REVISION TRANSMITTAL

This sheet transmits Revision 1 to SB680-34-41 which:

NAVIGATION - INSTALLATION OF DUAL LITEF HYBRID NAVIGATOR UNITS AND RNP AR = 0.3 SOFTWARE

MODEL	SERIAL NUMBERS
680 (Citation Sovereign+)	-0501 thru -0600

Figure 1. Installation of the Dual Litef Hybrid Navigator Units and Configuration Modules (Sheet 1)

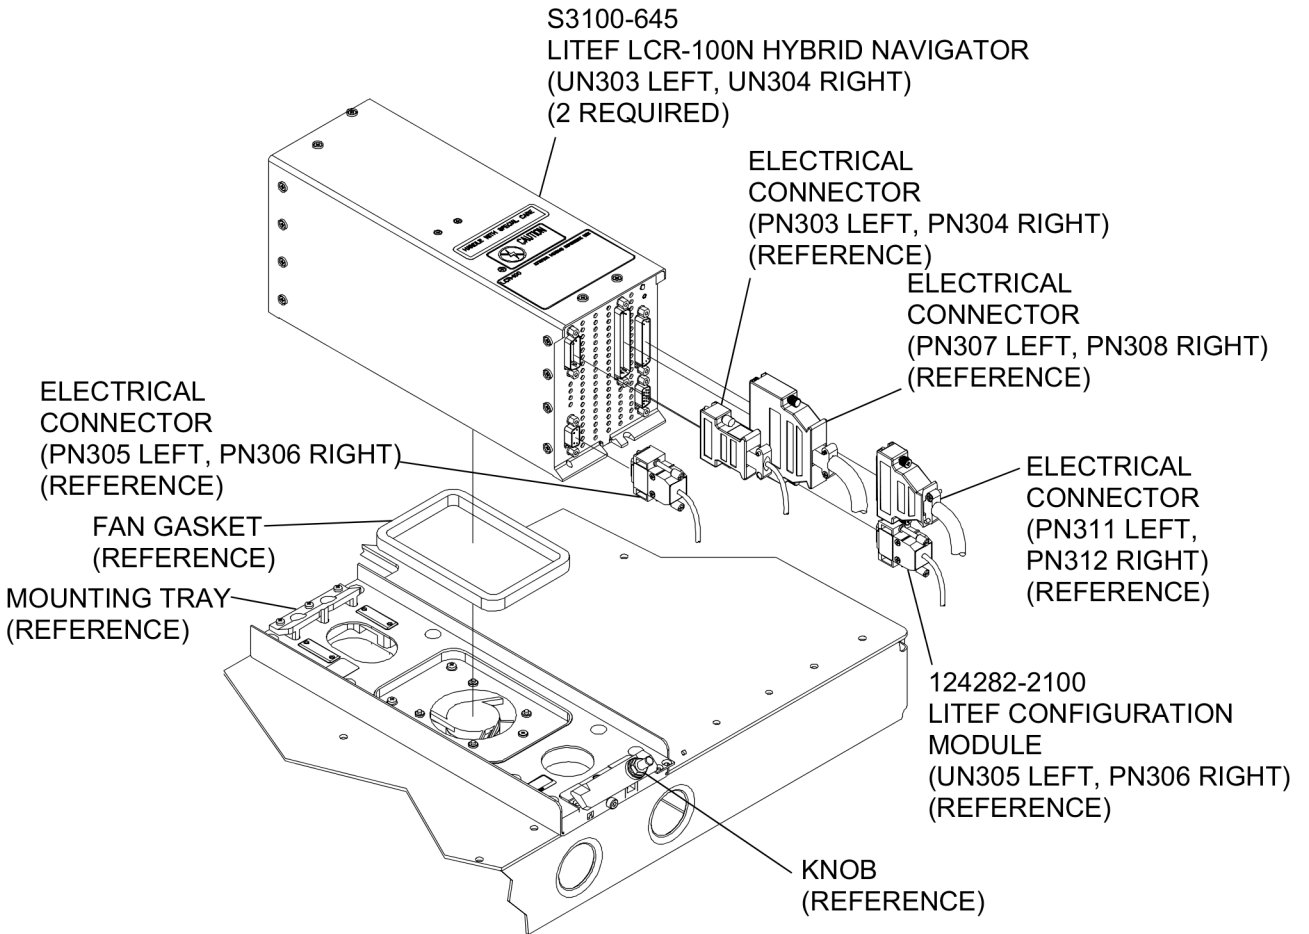
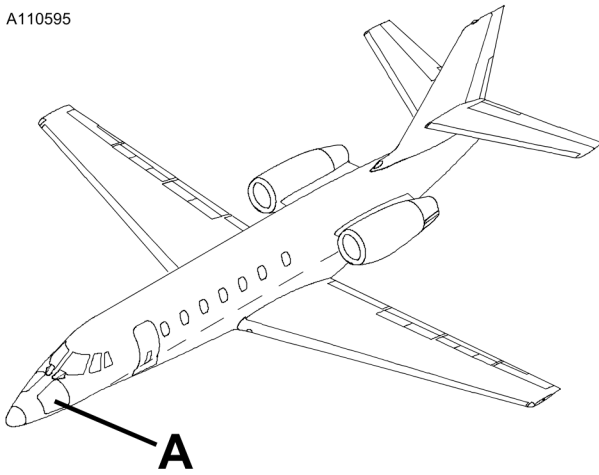
- A. Removed the instructions to remove the 124282-2100 Configuration Module from Step 2.
- B. Removed the instructions to install the 124282-2200 Configuration Module from Step 2.
- C. Removed the Adjustment/Test for the Litef LCR-100N from Step 2.
- D. Added Step 3.
- E. Removed the 124282-2200 from the Material Information Section.
- F. Removed 124282-2200 Configuration Module from the illustration.

2. (Refer to Figure 1, Detail A.) Install Upgraded Dual Litef Hybrid Navigator Units as follows:
 - A. On aircraft with 145130-3000 LCR-100N Hybrid Navigator Units installed, do the steps that follow:
